AMENDMENT NO. 2 NOVEMBER 1989
TO
IS : 7371 - 1982 SPECIFICATION FOR STAINLESS
STEEL, SAFETY RAZOR BLADES

(*Second Revision*)

FIG. 3 STAINLESS STEEL SAFETY RAZOR BLADE PIN TYPE

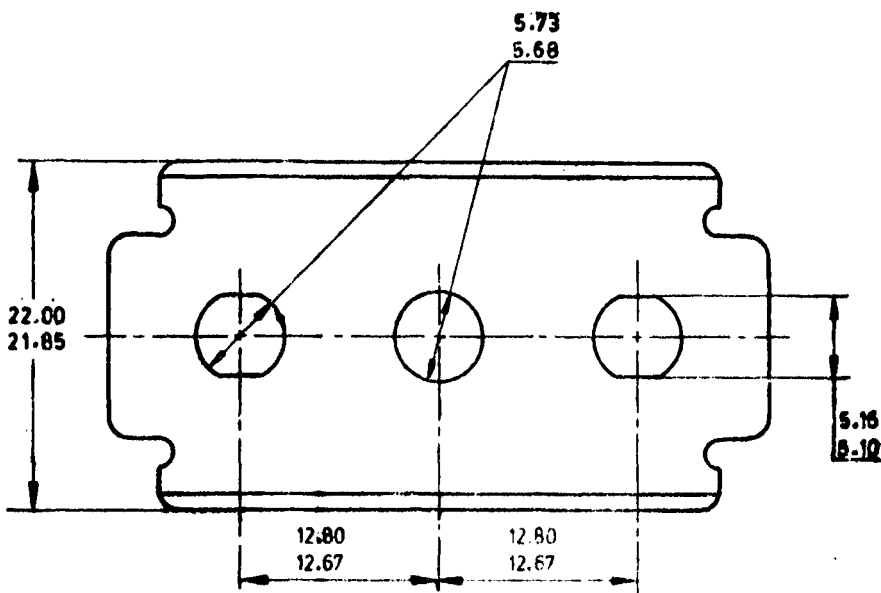
(*Page 4, clause 5.1.1*) — Add the following new clause **5.1.2** and Fig. 3 after this clause:

'5.1.2 The critical dimensions of the blade for pin type razor shall be as shown in Fig. 3.'
